2020-2024MY
Forte (BDm) and
2020-2022MY
Soul (SK3)
w/Gamma 1.6L T-GDI

263

TECHNICAL SERVICE BULLETIN

MISFIRE CONCERN DUE TO
OVERRUNNING ALTERNATOR DECOUPLER

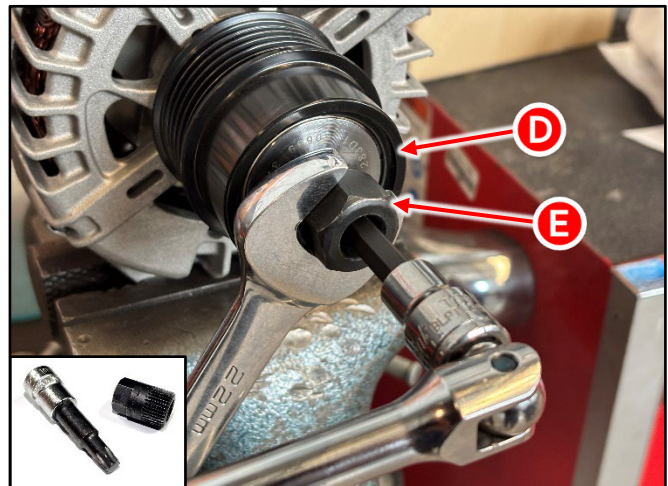
4. Remove the OAD (D) using the Alternator Pulley Remover/Installer (E).

Note: To remove pulley, hold the open wrench (counter-clockwise) while turning the Torx Bit Driver Socket clockwise.

Tightening torque for OAD/OAP T50 (X):
55.7 - 60.0 lb.ft (75.5 - 81.4 N.m)

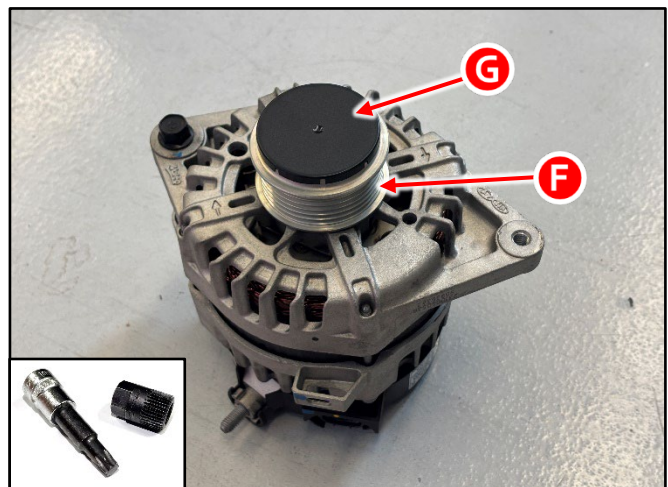
5. Install the 'new' parts included in the OAP kit to the alternator assembly:

- OAP (F)
- OAP Cap (G)

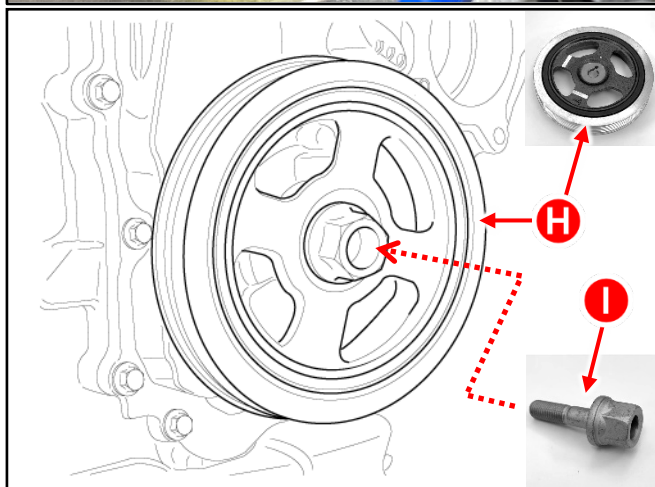
6. Replace the crankshaft damper pulley (H) with a new part included in the OAP kit by referring to "Engine Mechanical System → Drive Belt System → Crankshaft Damper Pulley → Repair procedures" in the applicable Shop Manual on KGIS.

Install the supplied 'new' crankshaft damper pulley bolt (I) included in the OAP kit.

Tightening torque for nut/bolt (I):
36.2 lb.ft (49.0 N.m) plus +53° degrees

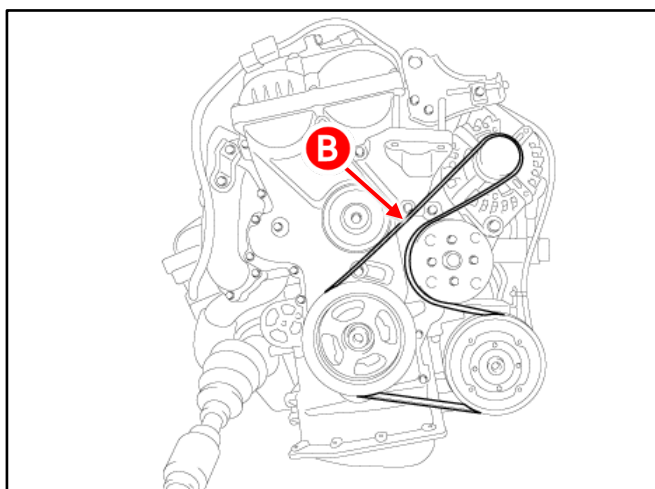
7. Install the new supplied drive belt (B) included in the OAP kit.

Note: Correct routing of the drive belt (B).
